QUESTIONS AND RESPONSES

**TOTEM LAKE CONNECTOR BRIDGE
JOB # 01-20-PW/NMC0861000**

CITY OF KIRKLAND, WASHINGTON

QUESTIONS RECEIVED THRU FEBRUARY 13TH, 2020

SHEET: **TLC-S-138**

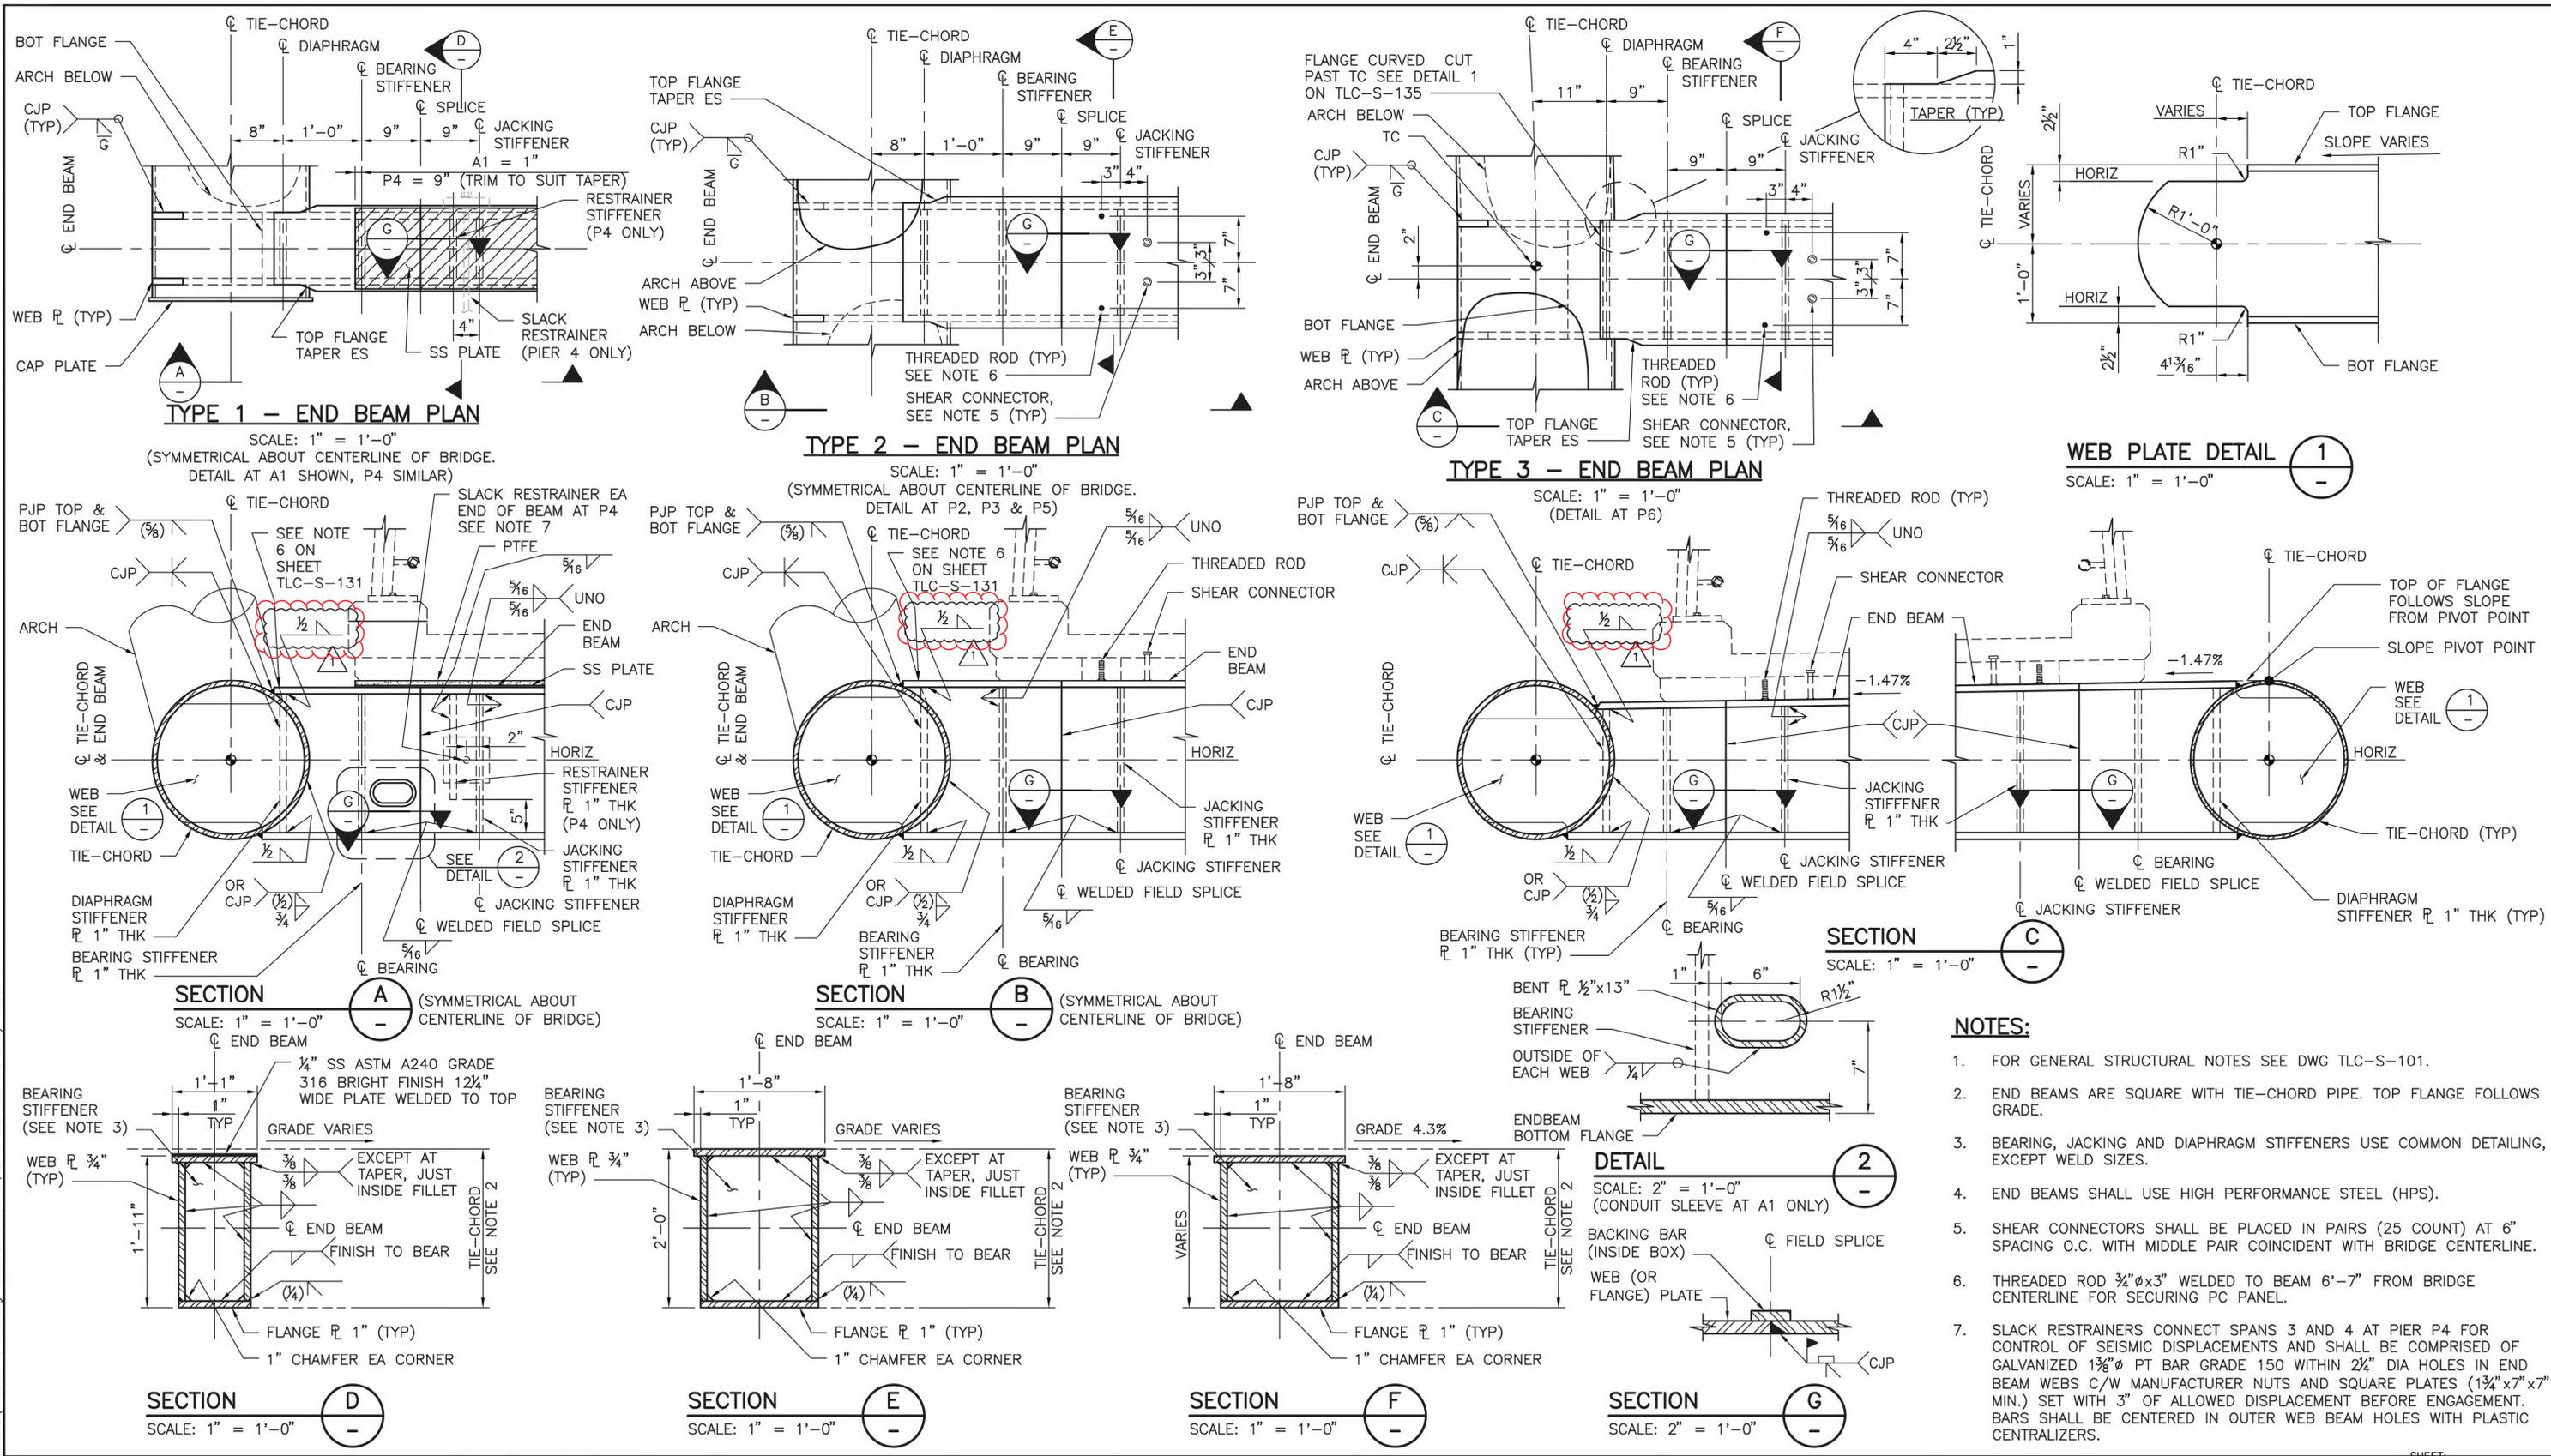
1) Type 1 Section A

- a. The weld callout for the Diaphragm Plates shows ½" fillet on both sides at the top of the plate. If that a typo and to only be on one side similar to the bottom weldment?
- b. On the same Diaphragm Plate, please confirm if the side weldments are to be CJP's or ½" Fillets similar to the top and bottom welds.
- c. Where the weldment is called out for the outer side of the End Beam Web Plate to the Tie-Chord, it shows a CJP (1/2") with a Reinforcement Fillet (3/4") and the word "OR". What is the "OR" Option? I don't see that noted anywhere in the drawing package.

2) Type 2 Section B

- a. The Bearing Stiffener shows that a double sided fillet (assumed 5/16") if required on 3 sides of the plate however that is not feasible with the top flange on the built up member and the Diaphragm Plate already welded in. Could a knife bevel PJP be utilized in lieu of the double sided fillet? If so what weld size is acceptable?
 - i. This would also be the case with the Jacking Stiffener and Restrainer Stiffener as well. Please advise the same solution as the Bearing Stiffener.

4) Note 4 on DWG TLC-S-138

- a. The material requirement calls out HPS grade steel for the End Beams. Please confirm if HPS-50W is acceptable for End Beams.
- b. For material types, does the HPS grade only apply to Plate, Angle, and Bar? Please clarify which material type is to be HPS.

Please see the attached amended drawing (TLC-S-138), particularly sections A, B and C. We intend to make this part of an amendment to the contract to be issued this week.
(See Addendum No. 1 for modified drawing TLC-S-138)

- 1a) The weld to the top flange should be single sided, same as the weld to the bottom flange. This will be revised via Addendum. (See Addendum No. 1 for modified drawing TLC-S-138)

- 1b) The welds between sides of diaphragm plate and webs of end beam are to be CJP as noted.
- 1c) The intent of the weld callout is that a 1/2" PJP + 3/4" reinforcing fillet, or CJP weld is acceptable.

- 2a) The design intent is that the bearing stiffener would be installed prior to the diaphragm plate, and the bottom flange of the box would be welded on last. A PJP with 3/4" effective throat is an acceptable substitution for the double-sided 5/16" fillet weld shown. This solution is acceptable for this size weld on all stiffeners. Please note the restrainer stiffener shows single-sided welds in Section A.

4a) HPS Grade 50W is acceptable.

4b) HPS applies to the flanges, webs, and stiffeners (diaphragm, bearing, jacking) of the end beams.
